STATE OF WISCONSIN
DEPARTMENT OF NATURAL RESOURCES

ENVIRONMENTAL IMPACT STATEMENT

THE FLAMBEAU MINING CORPORATION
PROPOSED COPPER MINE
RUSK COUNTY
WISCONSIN

Prepared by: Department of Natural Resources Staff
Date: February, 1976

FIGURE 19

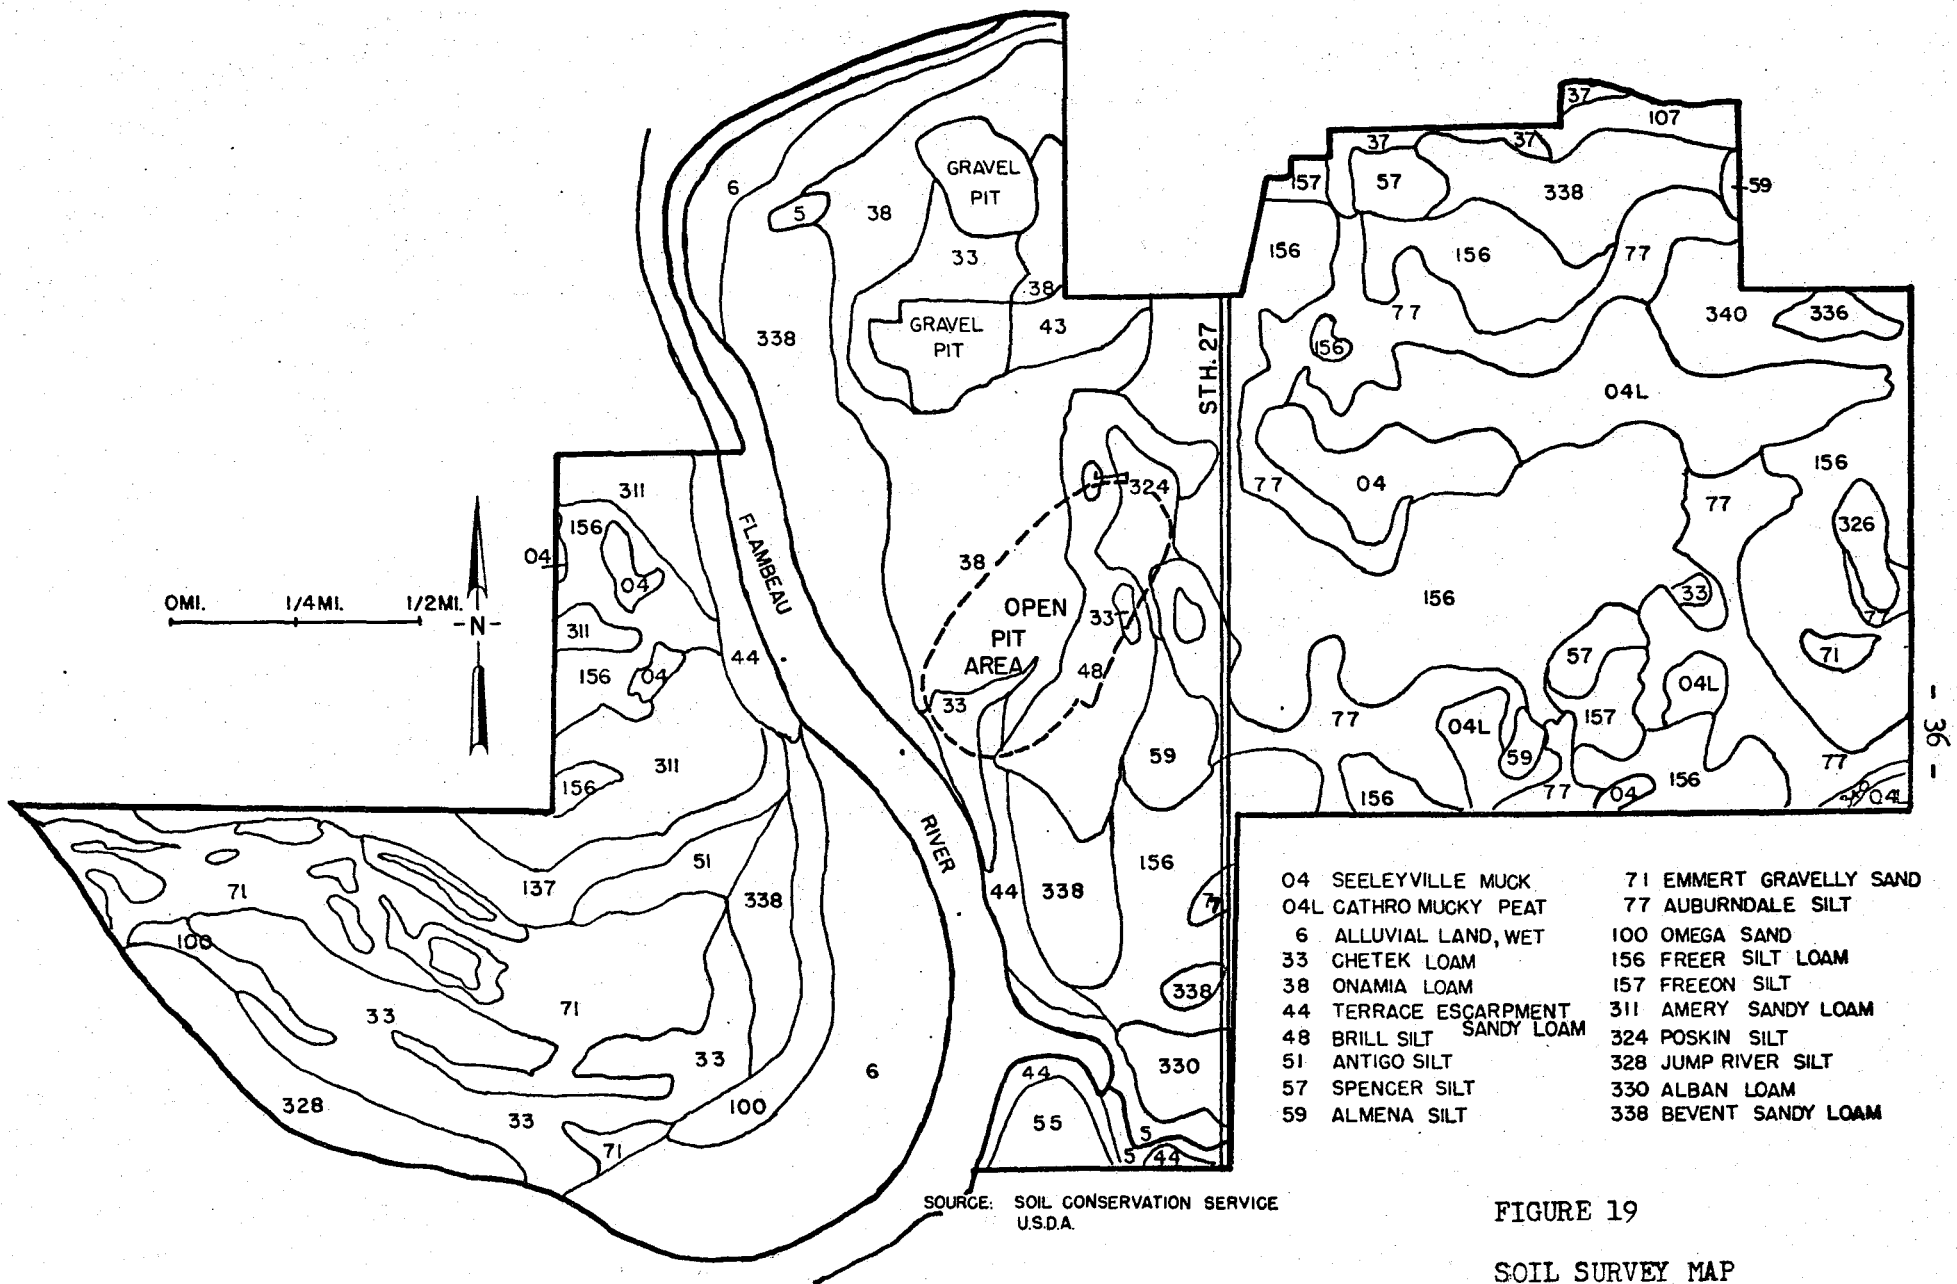
(15) The statement headed "Soils" on page 36 is incorrect in referring to geologic deposits as soils without indicating how the word "soils" is being used. Certainly the "predominant soil type" is NOT a reddish brown sandy loam. As seen on Figure 19 of the report and as seen on our general soil map of the state (see attached figure 1), the predominant soil type is a brown silt loam. I suggest the following rewording of this paragraph:

"Soils (in the pedologic sense¹; see Fig. 19) in the project area are predominantly silt loams derived from thin local loess overlying acid sand and gravel outwash and stony sandy loam reddish brown glacial till. These soils are productive of small grain and hay crops commonly planted on dairy farms of the area.
